IFB 3090

RUFFNER PROFESSIONAL DEVELOPMENT AND OPERATIONS CENTER REPURPOSING SERVICES

Addendum #6

PROJECT: RCPS Career and Technical Education Center

M4.2

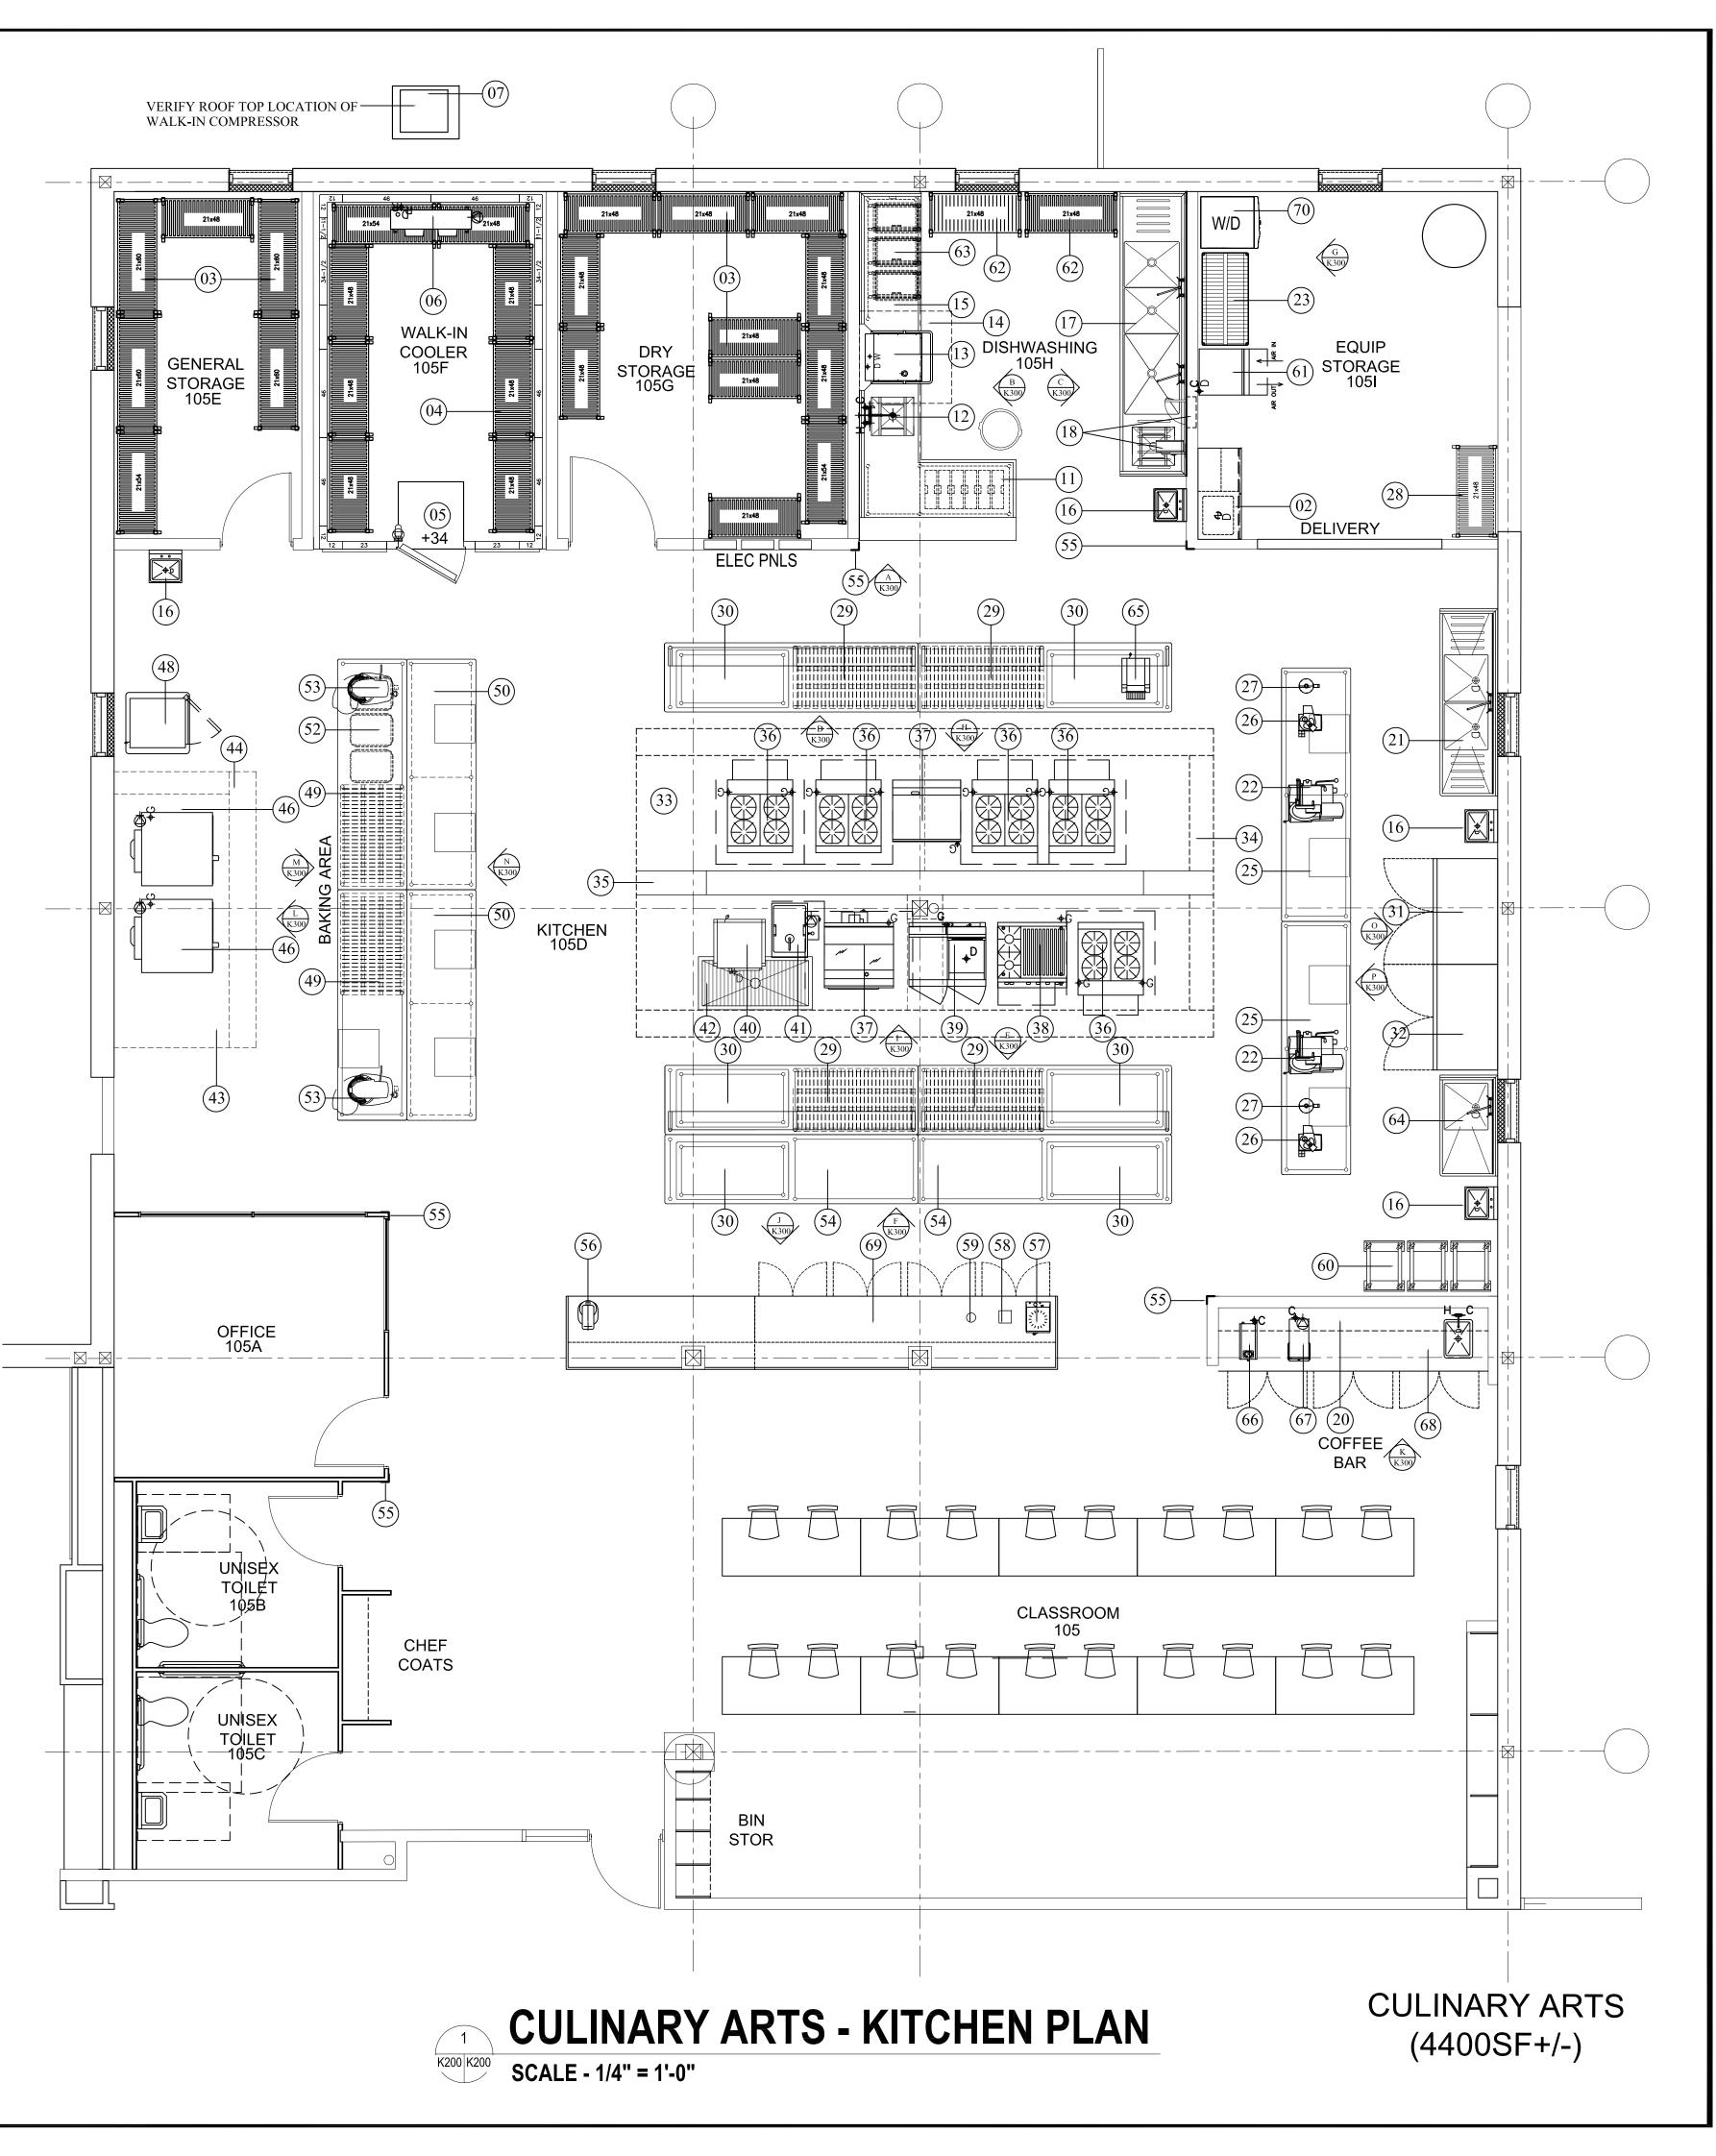
Please advise what window/storefront types are to be in these locations.	window type in .
29			Please provide a detailed drawing of how the Welding Dust Collector is to be secured to the	See revised Architectural Sheet A1.4 and M4.2 in Addendum 6. Note that the welding dust collector has
			building structure. I have not seen any revised documents showing additional structural steel	been relocated.
			for this.	
30			Please provide specifications for Screen Walls	See updated specification section 074213.13 - "Formed Metal Wall Panels" for screen wall requiirements.
31			Addendum 5, Q/A 8 States that the equipment screen walls as shown on A1.4 are to be	Screen wall systems are to be provided and installed by contractor. The screen wall system is to be provided
			purchased and installed by the successful bidder and where not pre-purchased with the Trane	at all sides of all rooftop HVAC units and the dust collector equipment.
